Seat Harness Routing
VN, VT

FSB 375-008, Seat Harness Routing

(August 2012)

W3076516

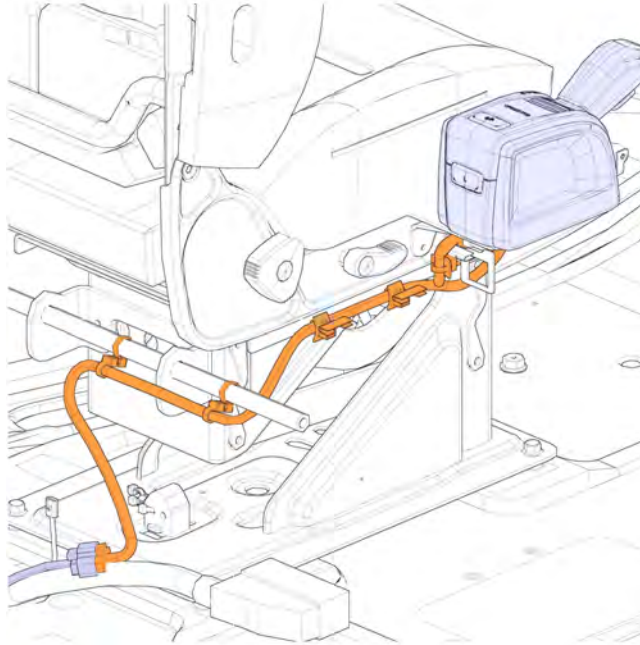
- 5 Remove the cable ties from each clip point until the shifter harness is free from the seat. Remove shifter harness.

Note: Look for chafed wires. Reuse harness if undamaged.

W3076417

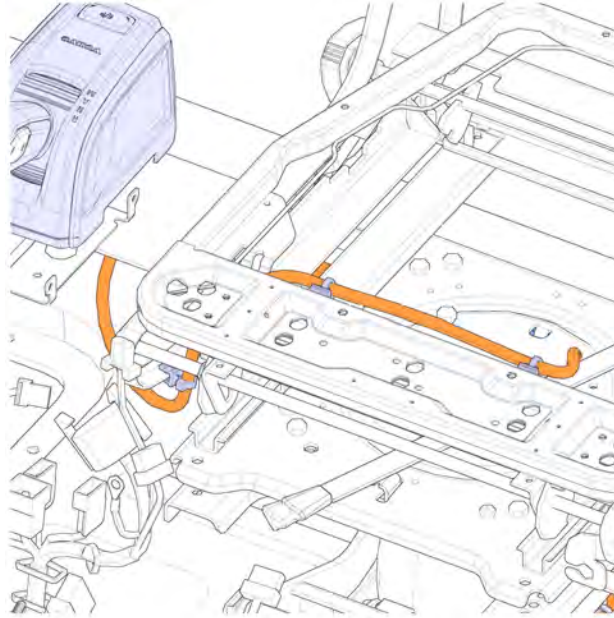
- 6 Flip seat cushion up and loosely install and cable tie the shifter harness along the new path for routing and clipping.

W3076420

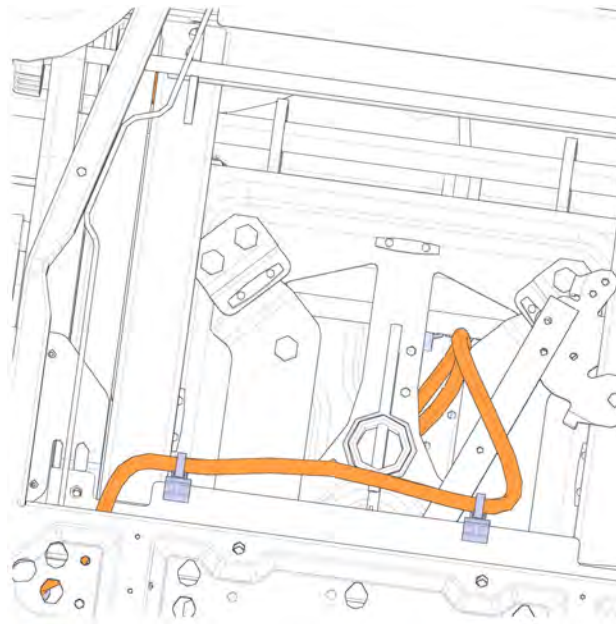
Cable Tie with Horizontal Edge Clip # 21096682, Qty 2

W3076419

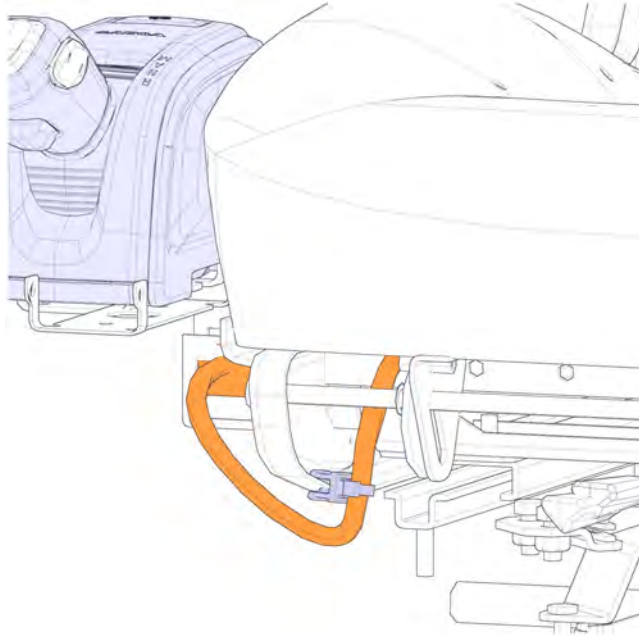
- 7 Secure the shifter harness by cinching all the cable ties until the corrugated loom is lightly snug.

Cable Tie with Vertical Edge Clip # 25375492, Qty 1

Note: Do not over tighten the cable ties, otherwise the wires and loom will become damaged.
